Summerlin V23B Sky Vista Dr. Alta to Fox Hills
Update #2

CITY OF LAS VEGAS		DATE:
INTER-OFFICE MEMORANDUM		May 9, 2019
TO: Land Development Services Department of Building & Safety		FROM: Albert Sung, P.E. Flood Control Project Engineer Department of Public Works
SUBJECT: Drainage Study for: Summerlin V23B Sky Vista Dr - Alta to Far Hills – Update #2		COPIES TO: GCW, Inc.
Cross Streets:	Sky Vista Drive from Alta to Far Hills	The Howard Hughes Company, LLC
File Number:	F:\Depot\DSMemos\DS4980F.doc	Bart Anderson, P.E., DevCo
Parcel Number:	137-22-000-017	CCRFCD
Zoning Action:	MDR-72841	
FEMA Flood Zone	YES NO X	
Proposed Storm Drain	YES X NO

**UPDATE #2 TO THE
TECHNICAL DRAINAGE STUDY FOR
VILLAGE 23B SKY VISTA DRIVE
ALTA DRIVE TO FAR HILLS AVENUE**

**Re: Update #2 to the Technical Drainage Study for
Summerlin Village 23B Sky Vista Drive – Alta Drive to Far Hills Avenue (DS4980)**

DRAWING 14
14 OF 46 SHTS

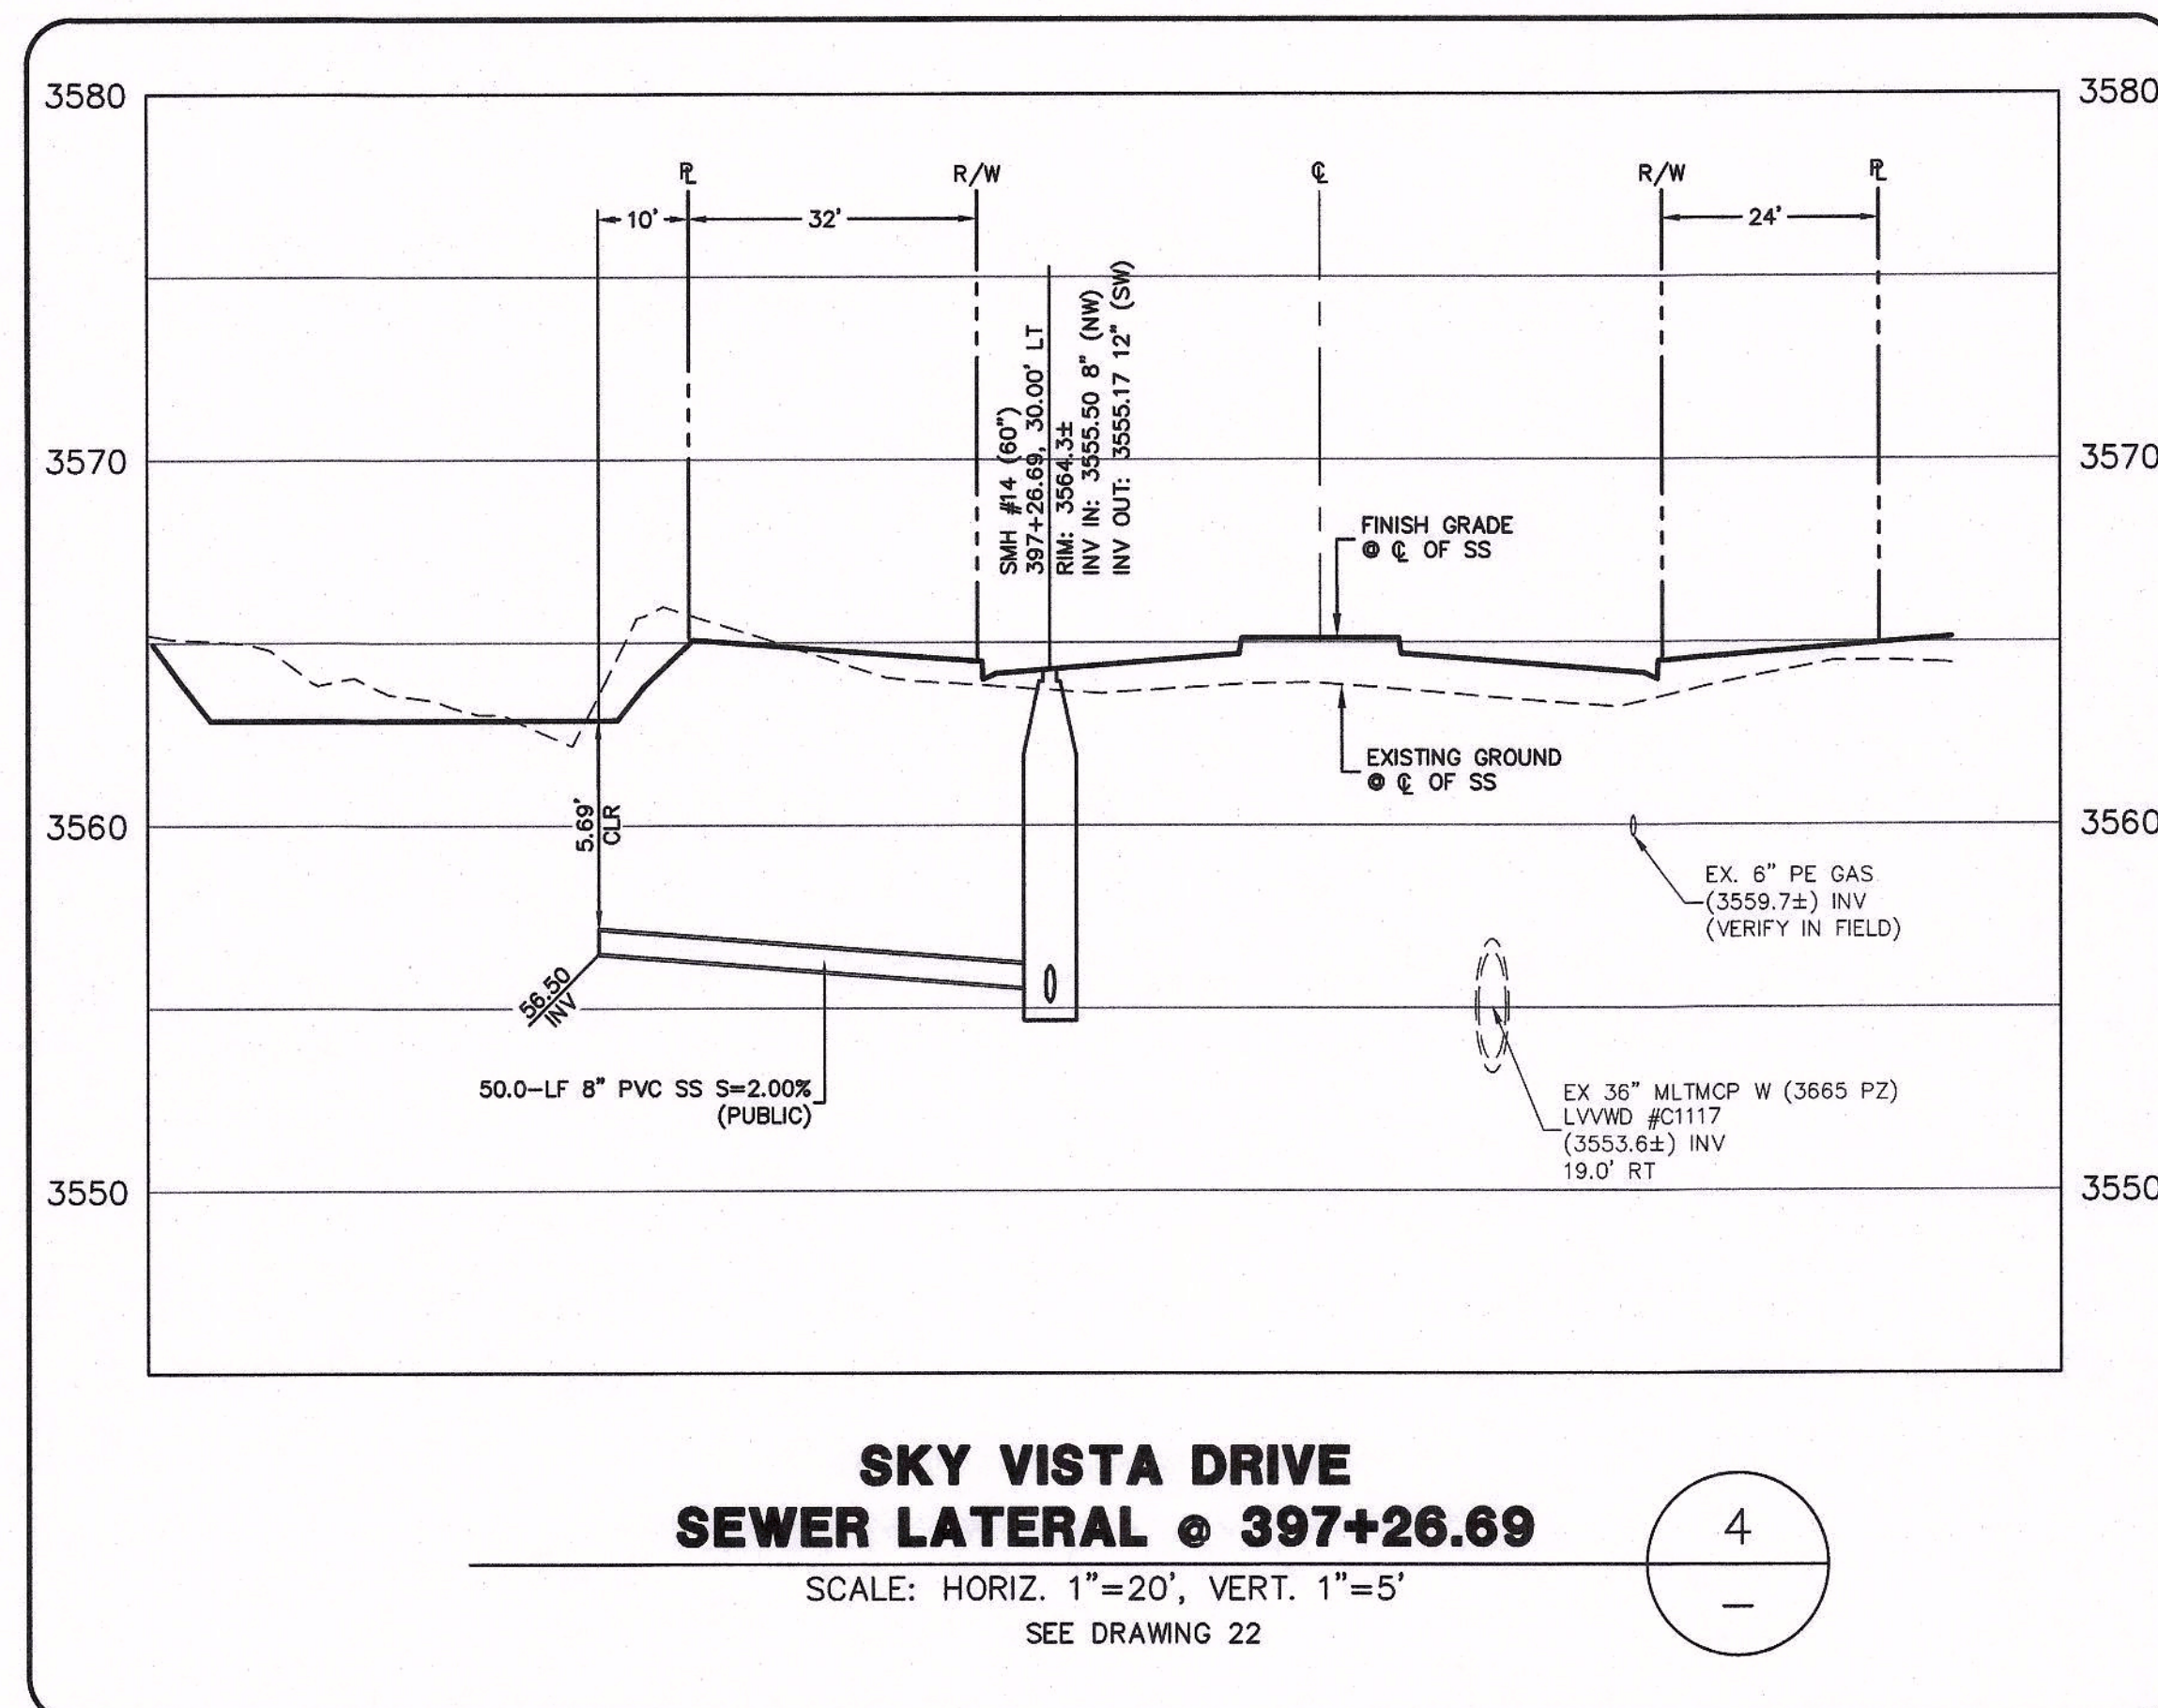
3. Revise all added nuisance drop inlets (DIs #7, #8, #9, #12, #13 and #14) to Type CM. Note that the lengths of CM inlets are in the multiple of 2.5'. Revise the length call out from 4' to 5'.
4. The segment of existing 60"-storm drain to be replaced with additional sacrificial concrete as shown on *Sheet 14* must be provided with a structural detail on the plans. A Special Construction Note must be added to the Grading Plans and the Plan and Profile Sheet that calls out the special construction requirement for the additional sacrificial concrete.
5. All offsite interim flood control facilities such as but not limited to berms / ditches and temporary sumps are privately owned and to be privately maintained by the *Howard Hughes Company*.
